**From:** [Diaz, Tammy, NMENV](#)  
**To:** [Smith, Steve W SWF](#);  
**cc:** [Cobrain, Dave, NMENV](#);  
**Subject:** Parcel 11, Bldg 11 sampling  
**Date:** Monday, October 19, 2009 4:11:00 PM  
**Attachments:** [Figure\\_5\\_2.pdf](#)

# Figure 5-2 Proposed Soil Sampling Locations SWMU 6 - Building 11 Fort Wingate Depot Activity McKinley County, New Mexico

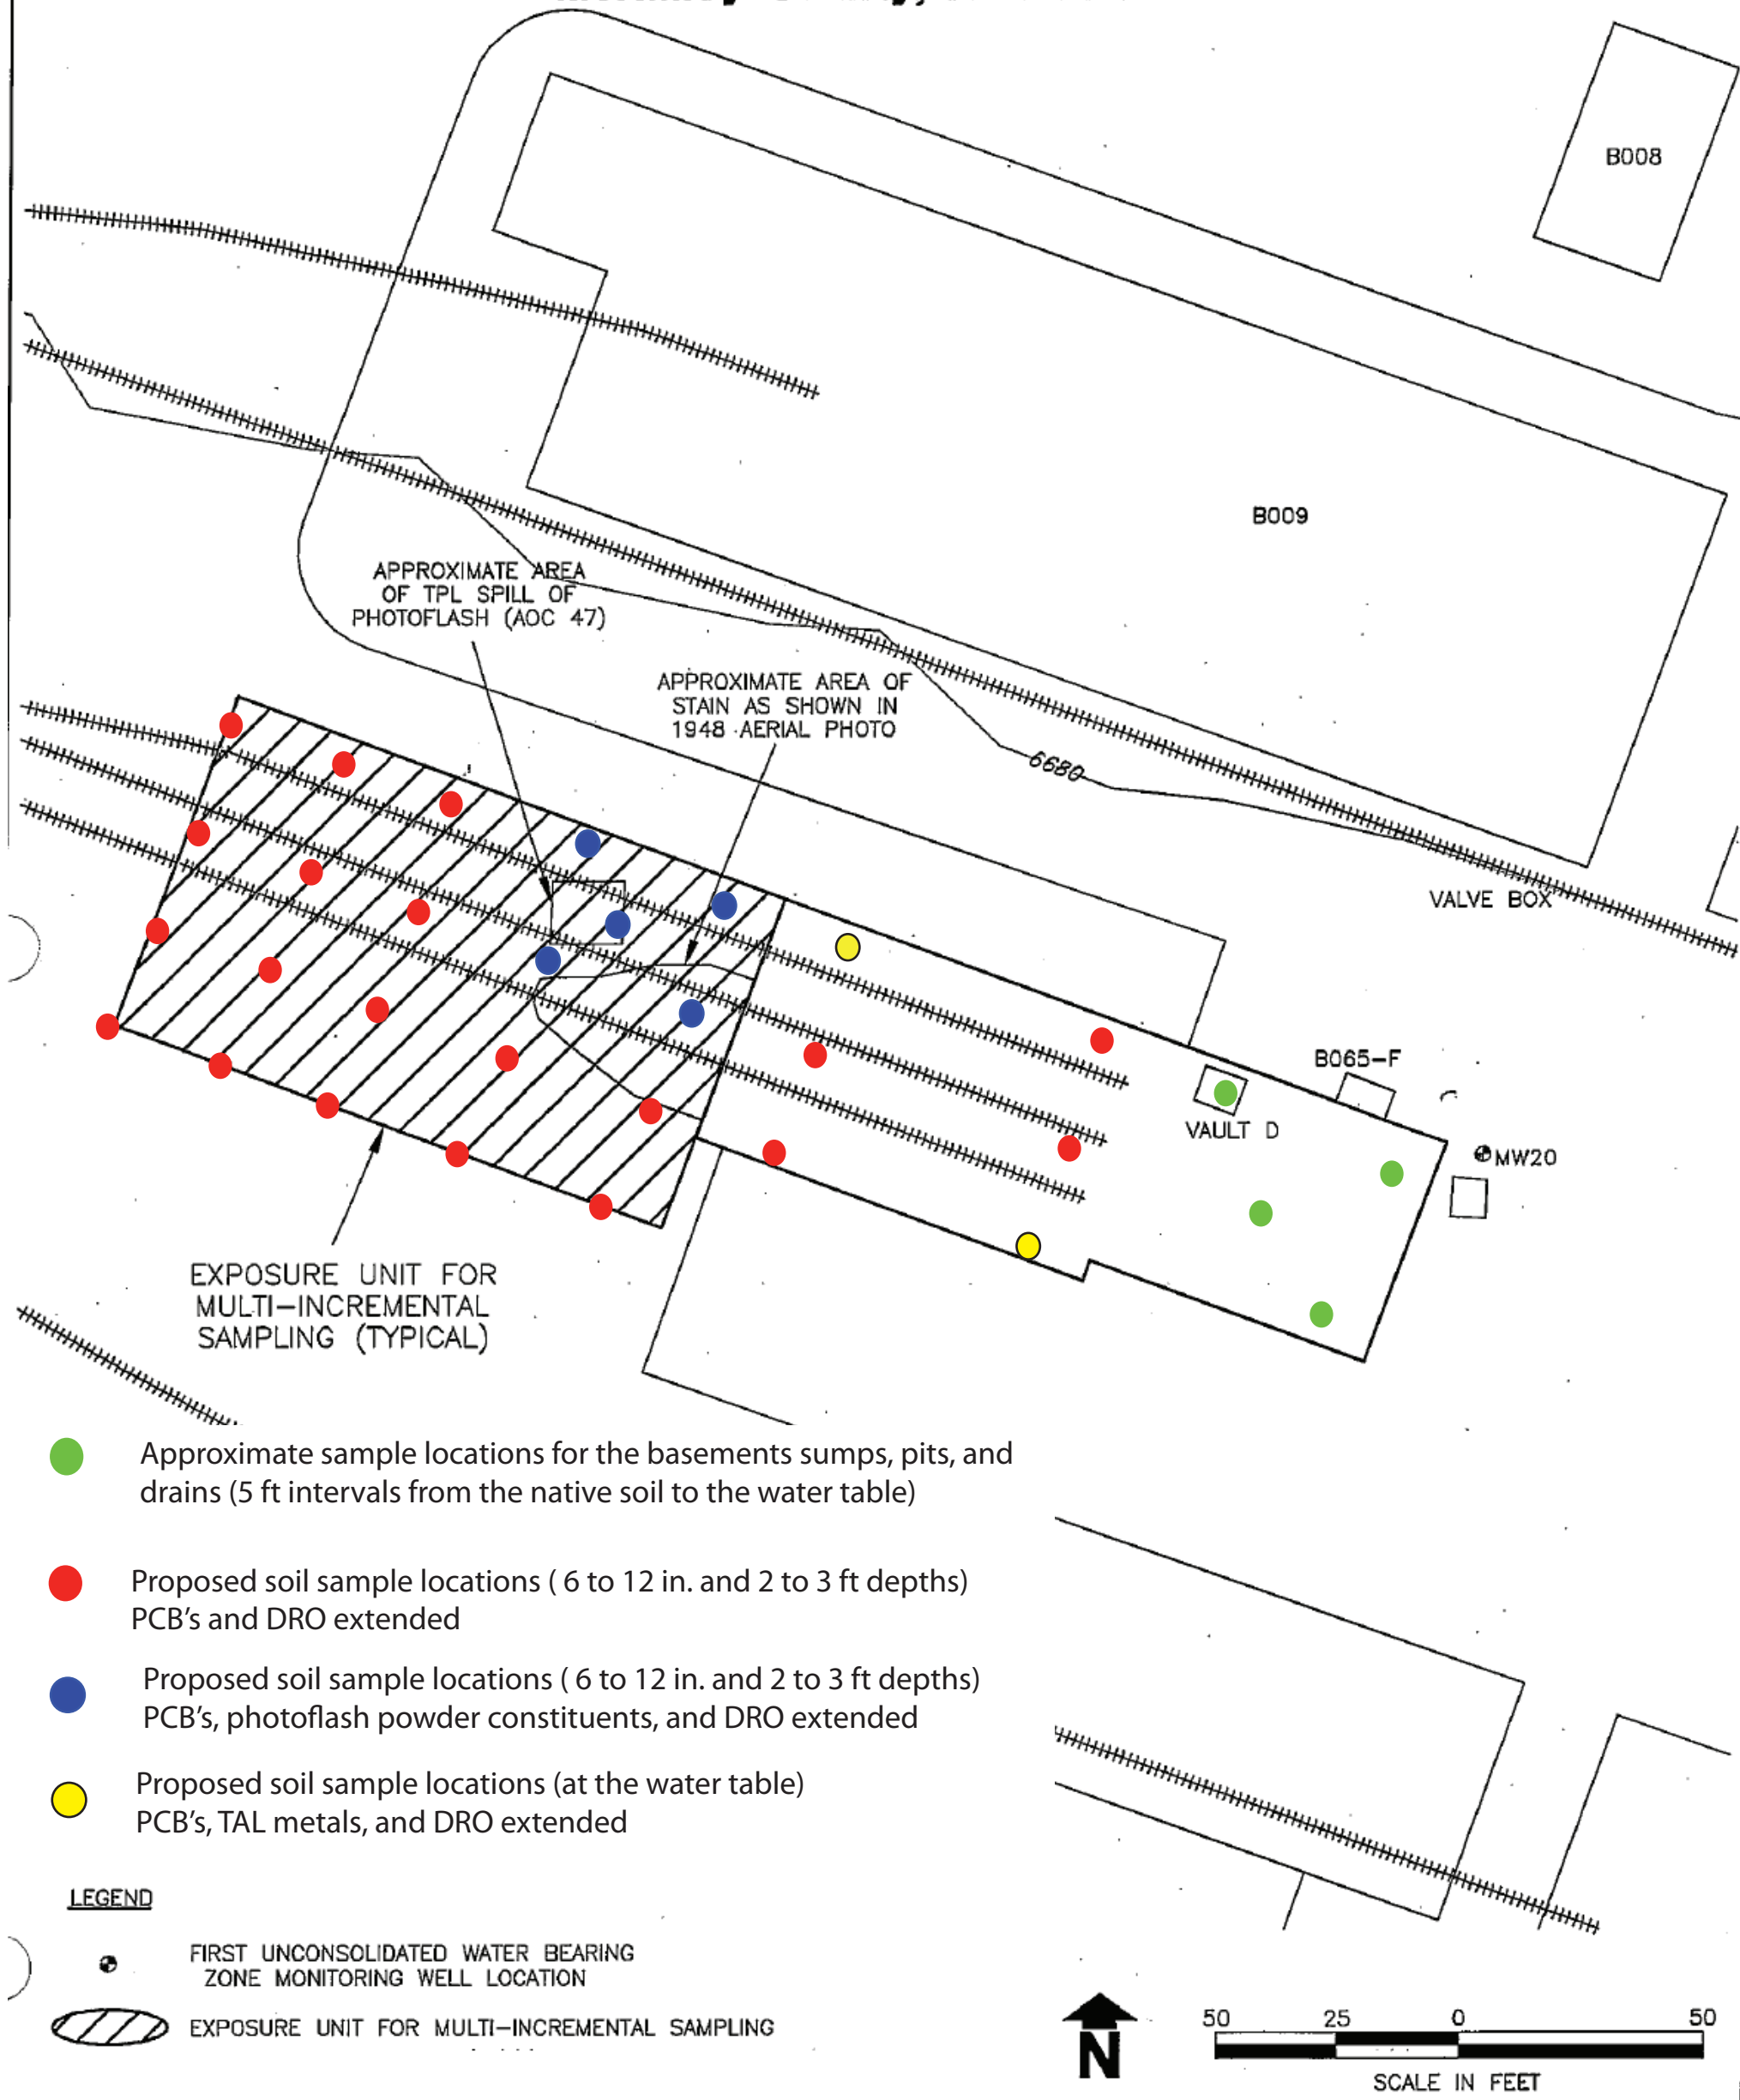
Attached is Figure 5-2, which is slightly modified from the original Figure 5-2 sent as an attachment to the Parcel 11 NOD dated December 23, 2008. Also, per our discussion at the meeting last week (10/14/2009), the Permittee may exclude the remaining sample locations as proposed in the Figure 5-3 of the revised Work Plan for Parcel 11 dated June 19, 2009. The Permittee must only sample at the locations shown on the attached figure 5-2, the only change is that the Permittee must collect soil samples at the water table from two locations (shown by the yellow dot) and include PCBs, TAL metals, and DRO extended in the analysis. You do not need to send a revision to the Work Plan, but please include this modification in the RFI Report for Parcel 11.
